STAFF REPORT: 05-12-21 MEETING

APPLICATION NUMBER: 21-7222

ADDRESS: 1920 ATKINSON

SCOPE: REHABILITATE HOUSE FOR ADAPTIVE REUSE AS RESTAURANT/APTS; BUILD EXTERIOR PATIO AT REAR

2 North Elevation
A2.0 1/4" = 1'-0"

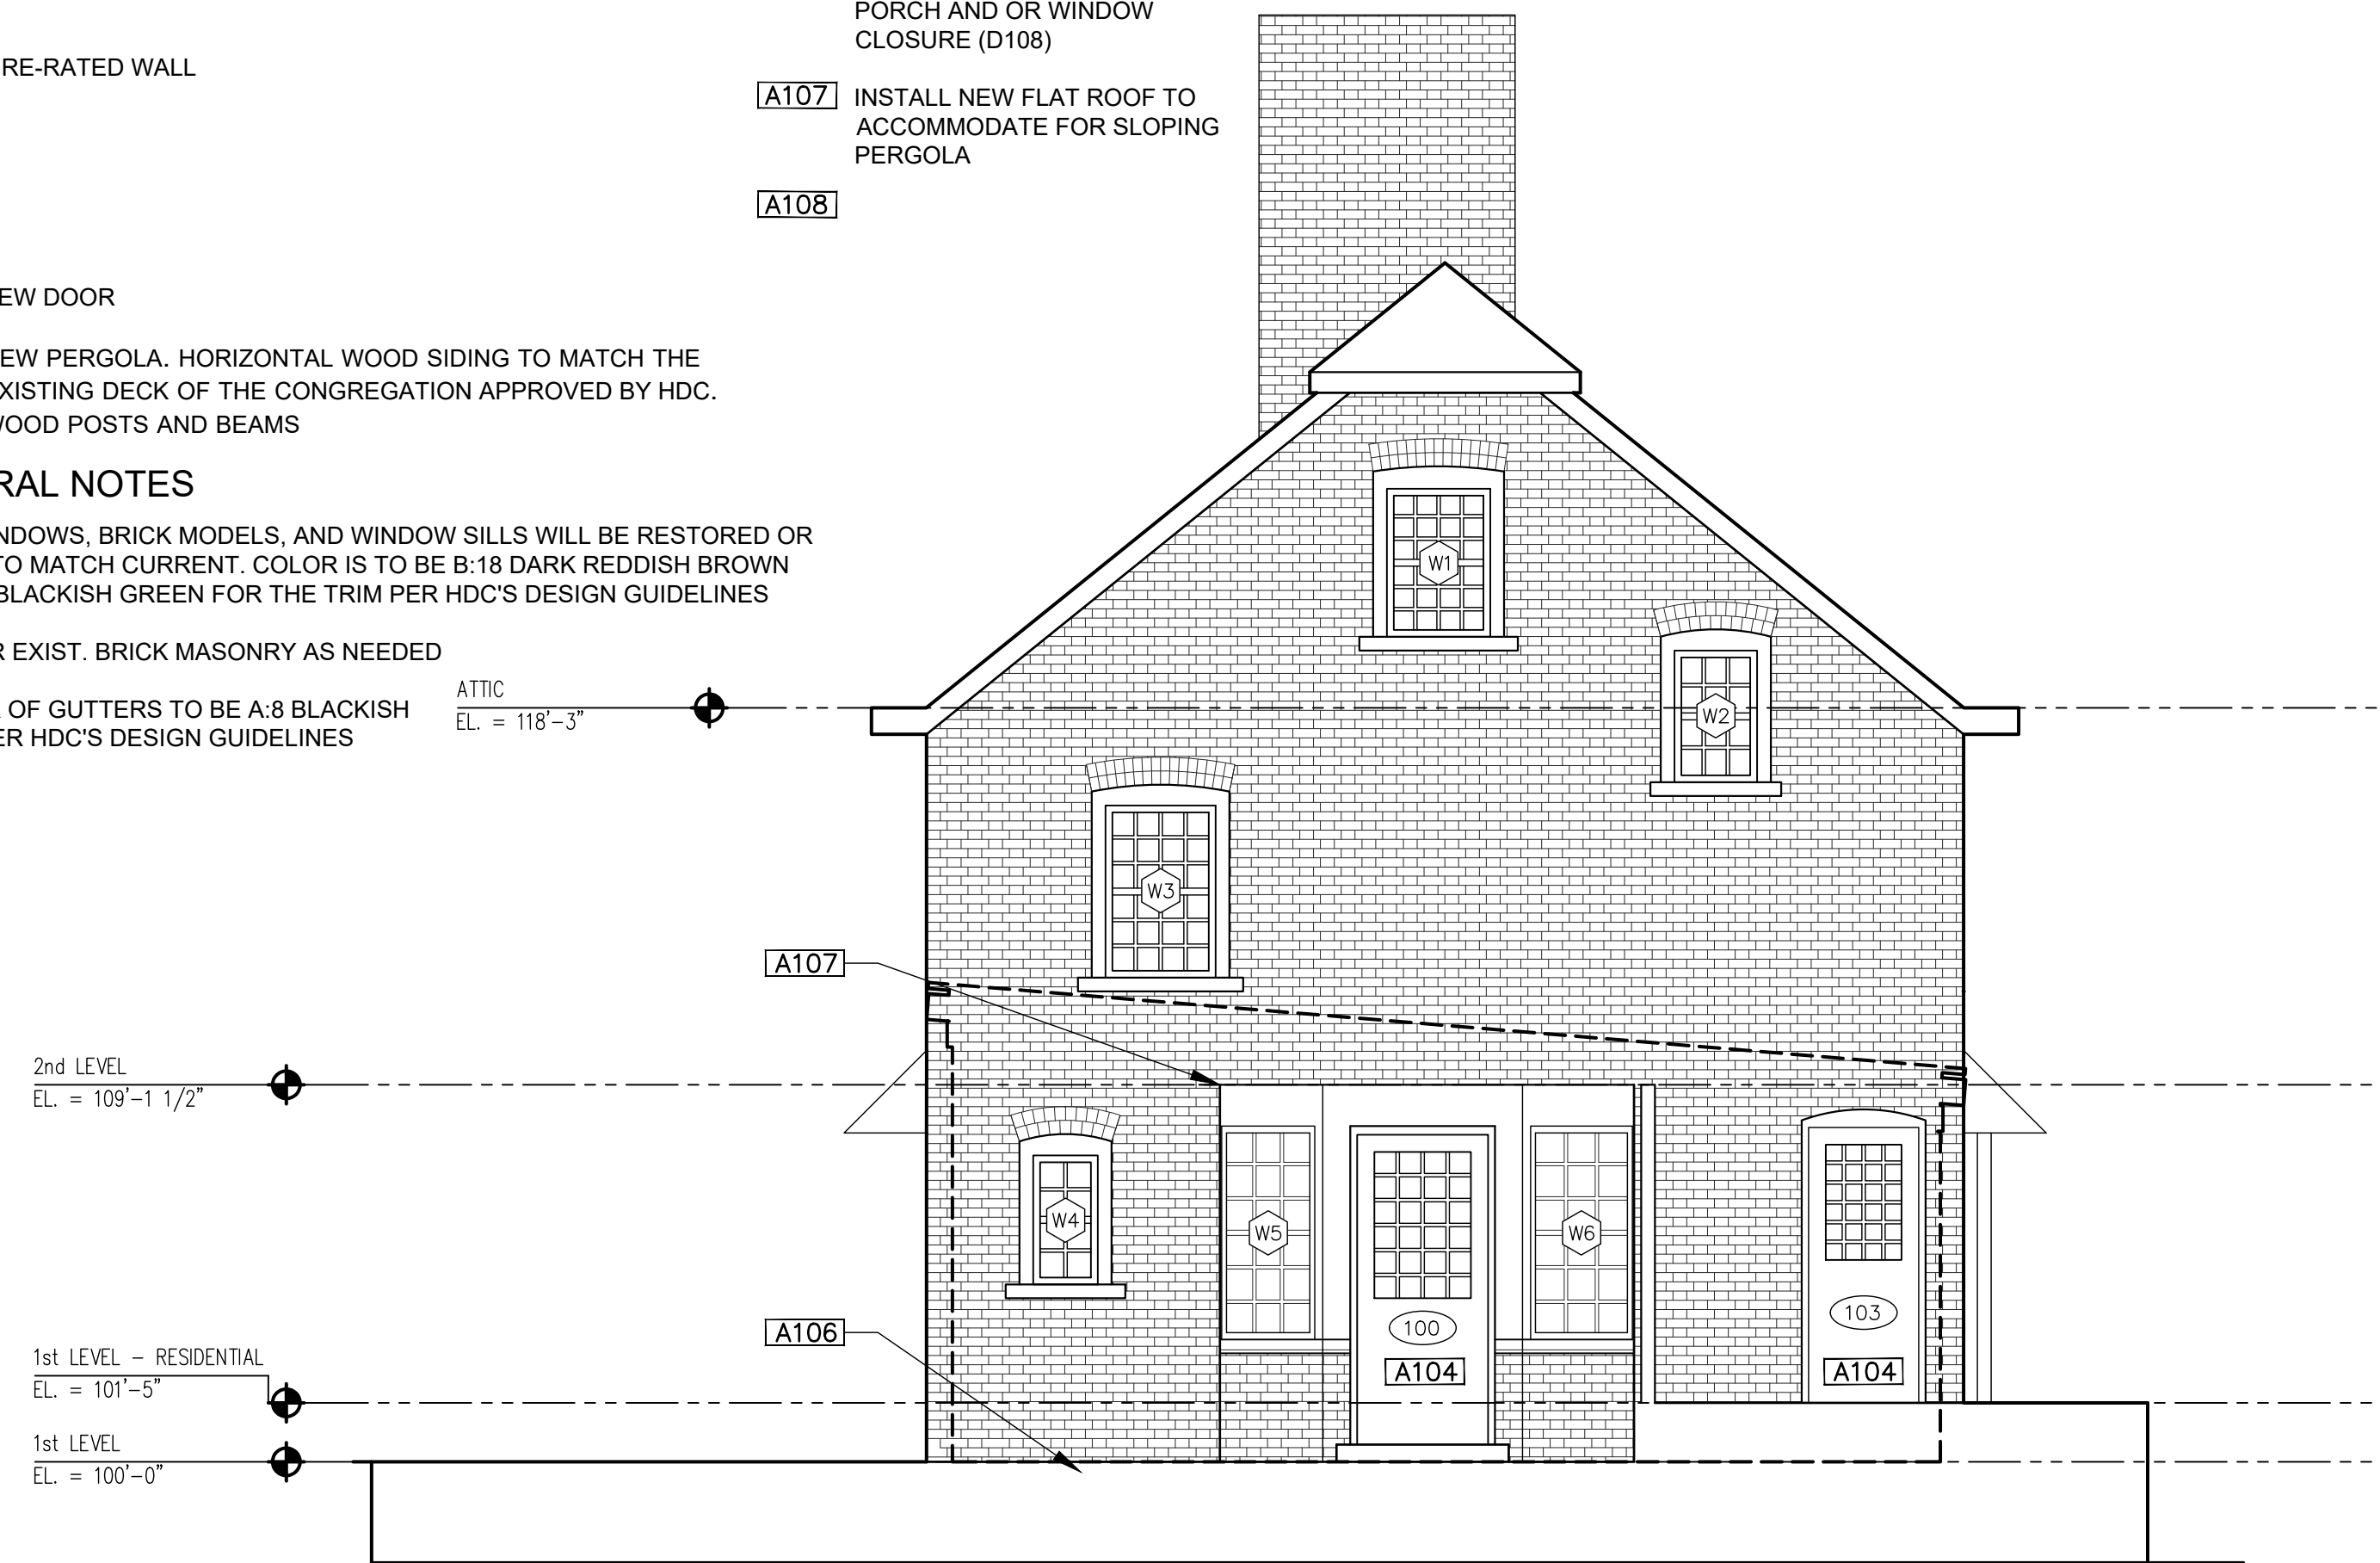
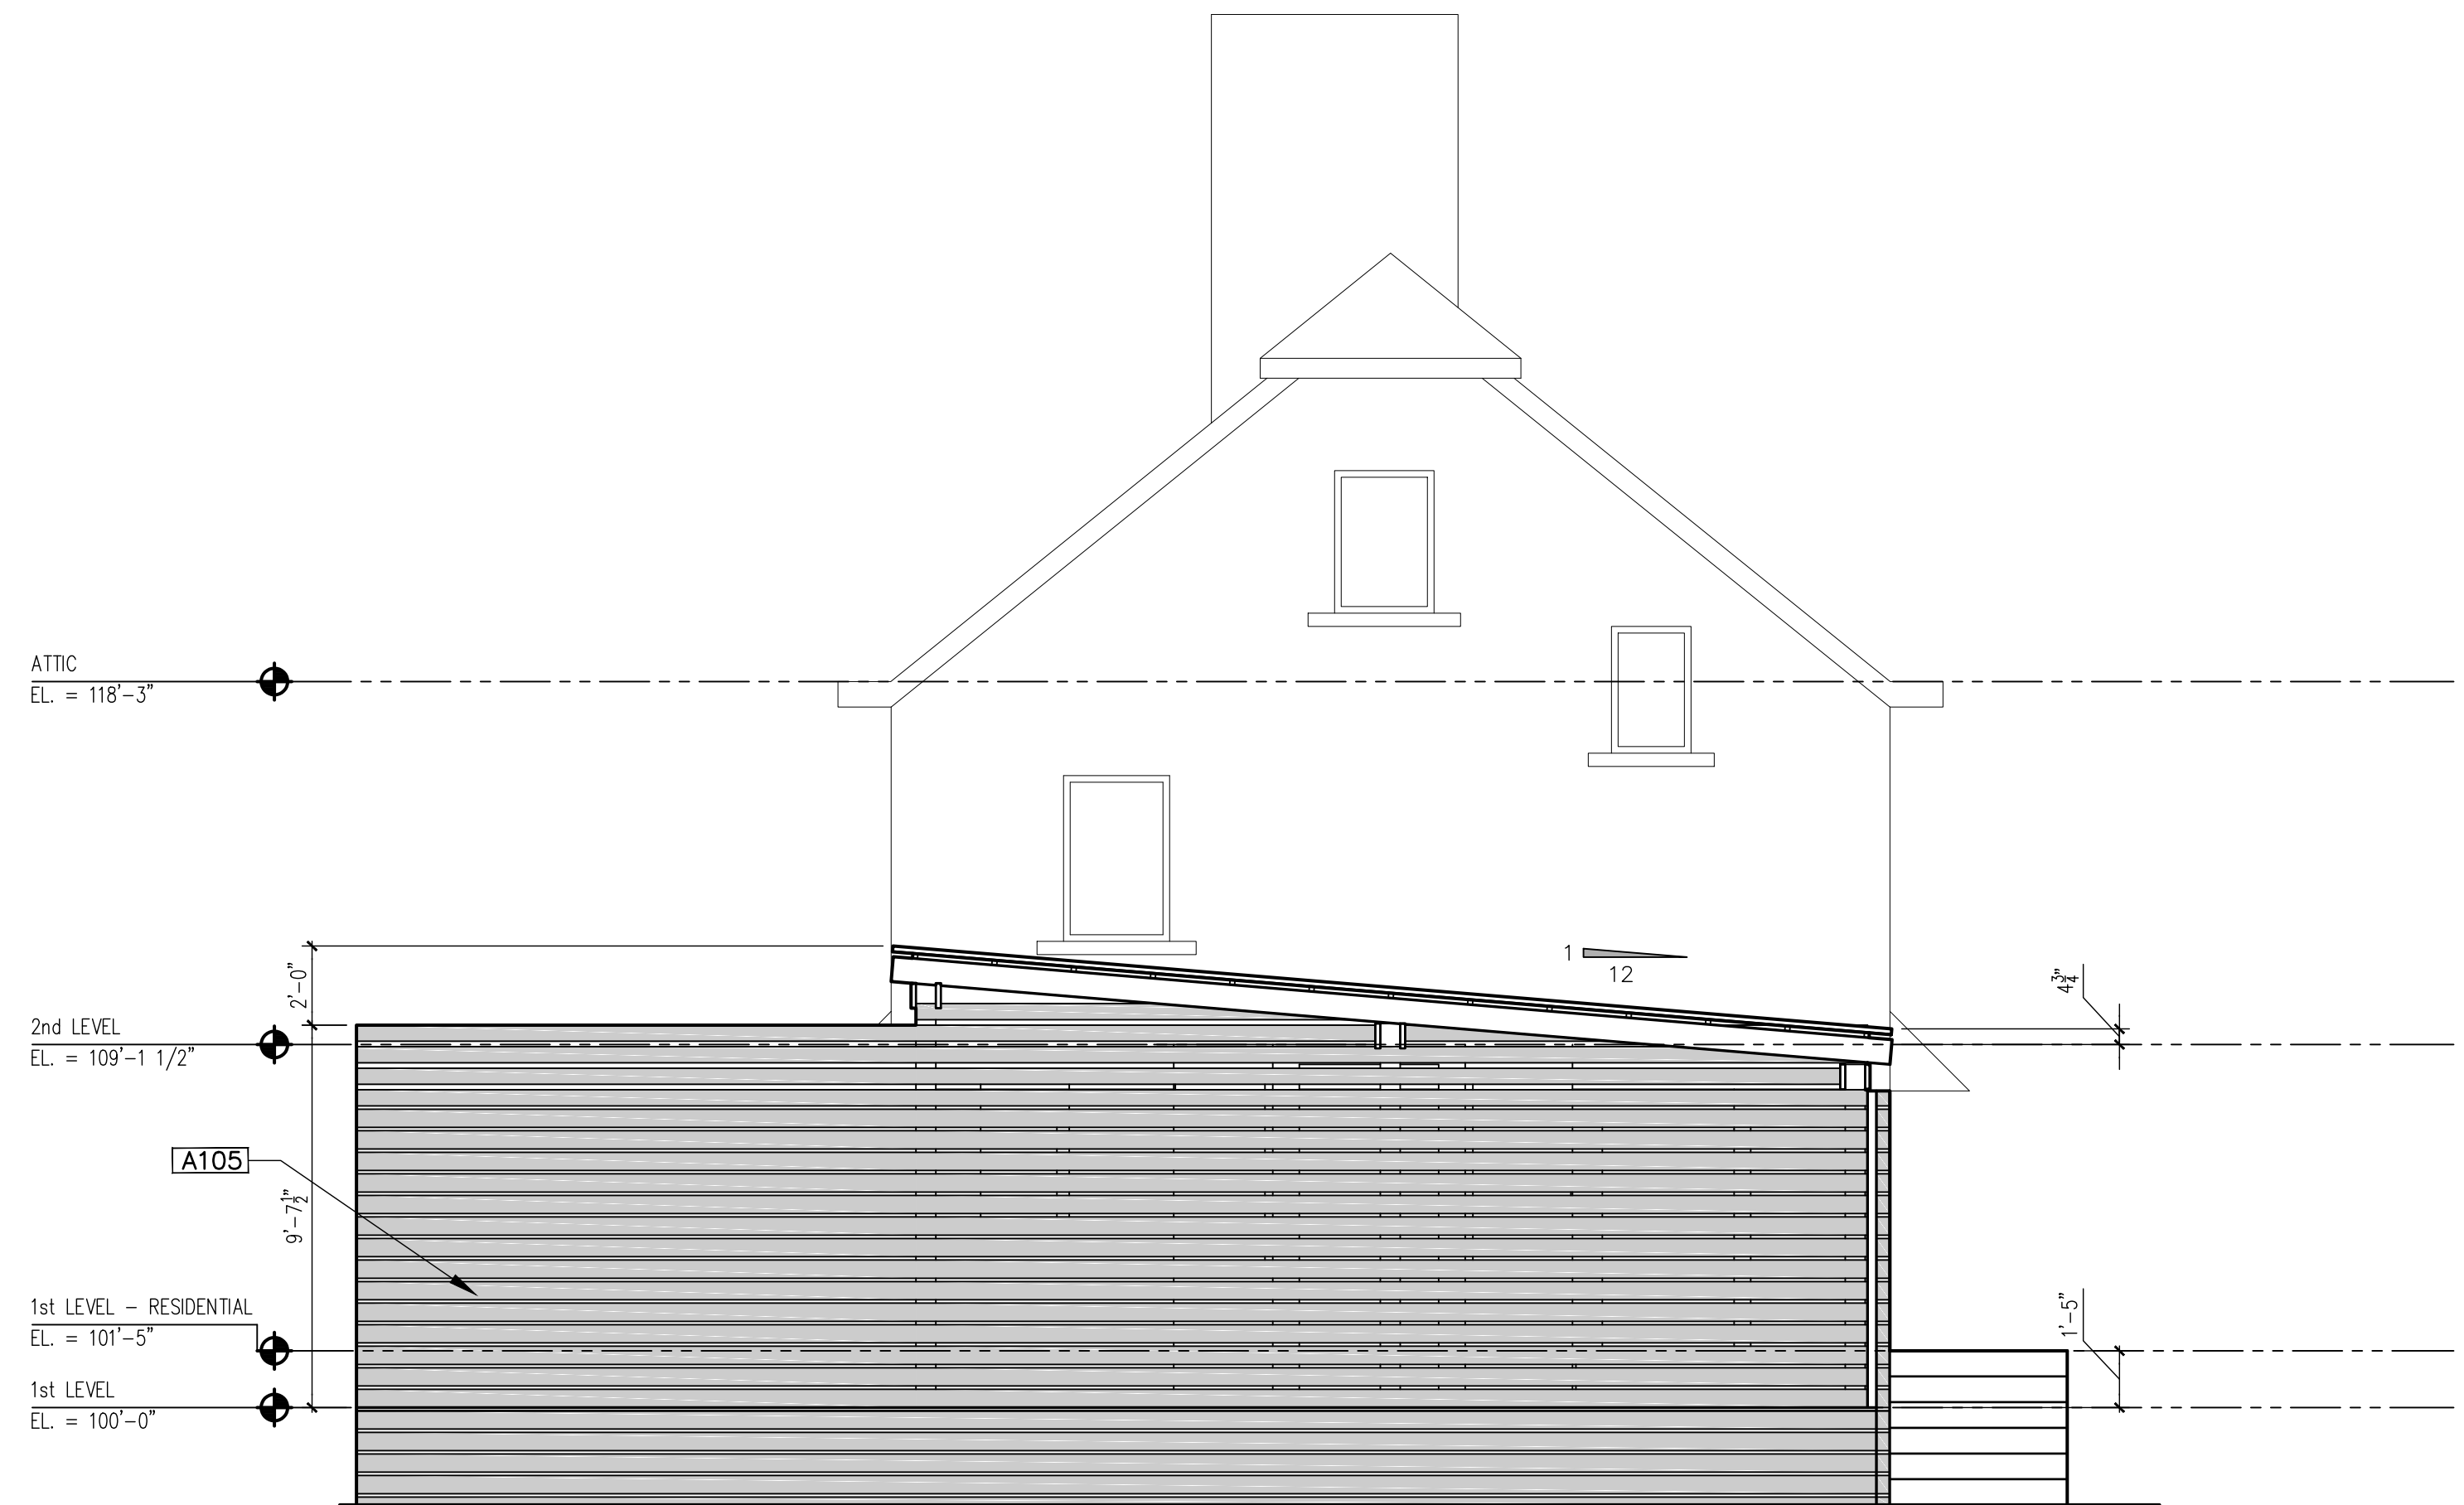
- Window and door removal on rear/north elevation. The elevation drawing shows the two openings removed (including double rowlock headers and brick toothed in), erasing all evidence of the historic openings. Per the proposal, it appears the sloping pergola roof (shown on the elevation as a sloping black line) will cross the window opening creating the need for a flat surface.

Will a flat roof be installed for the bay window due to the proposed sloping pergola? I don't see that the drawings address the removal of the bay window's existing roof.

It is noted the raised deck will match the raised deck design and construction at The Congregation. I am not clear on the full method of construction as I read the drawings. Will a visible concrete base be poured, which is how I read the elevations/renderings. Please clarify this elevation, and add the finished heights of the sloped pergola and rear wall.

Regarding the new rear entry stairs, please dimension this detail. Will a railing be required? Did you consider facing these stairs with brick as it extends beyond the NW corner of the house? Please confirm how much taller this platform will be than the new front entry porch.

Yes. This is now indicated in the scope of the work.

The deck of The Congregation is built completely out of wood and so will be the deck for The Rectory. There will be no visible concrete base. It will match the same style as the Congregation.

This platform will be 1'-5" taller than the adjacent porches. With this platform being taller than 30", railing will be required.
